Keystone House Boiler Replacement

Addendum #3: Questions and Answers

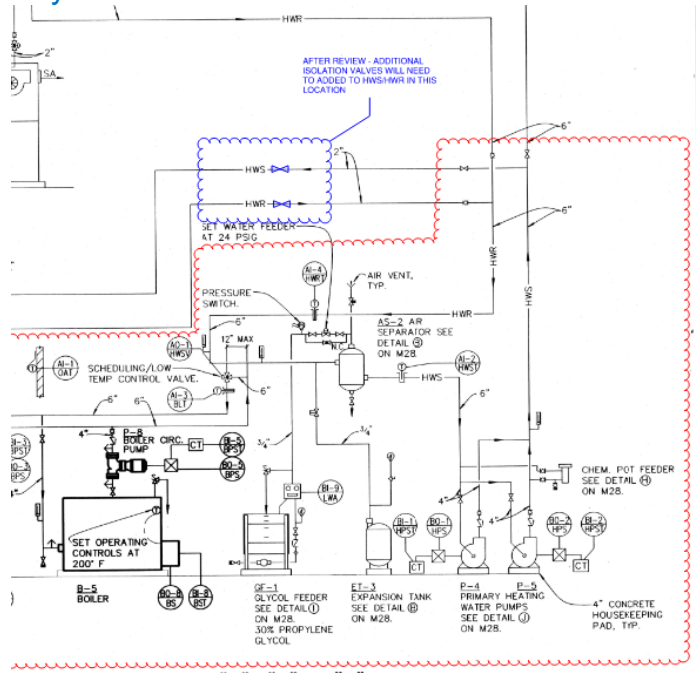
2) Where should we plan for connection points for Natural Gas?

a) At the nearest isolation valves within the mechanical room.

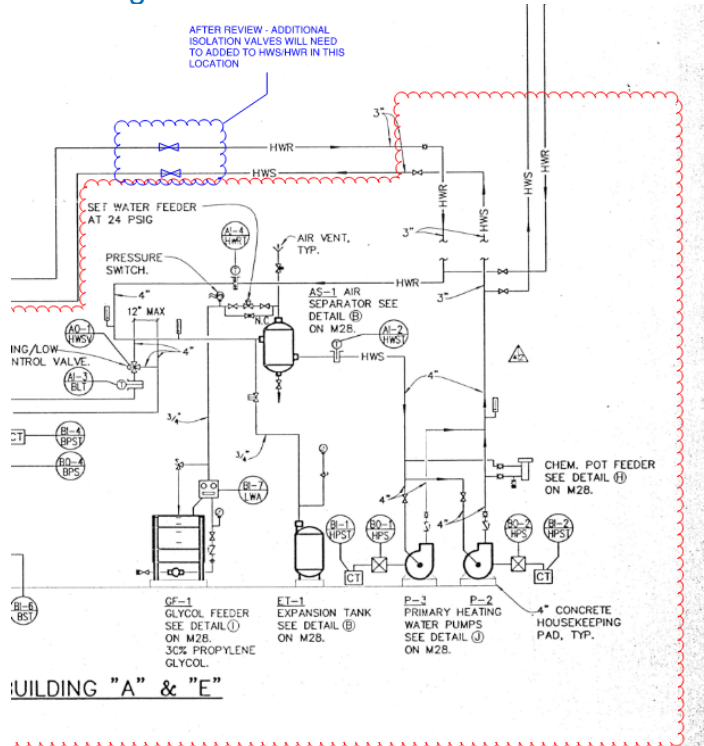
- 3) Where are the valves/scope ending? (For both jobs, but specifically the Lodge, there were not Iso valves in the Mechanical rooms)
- a) Provide valves in locations shown below.

i) Keystone House

ii) The Lodge
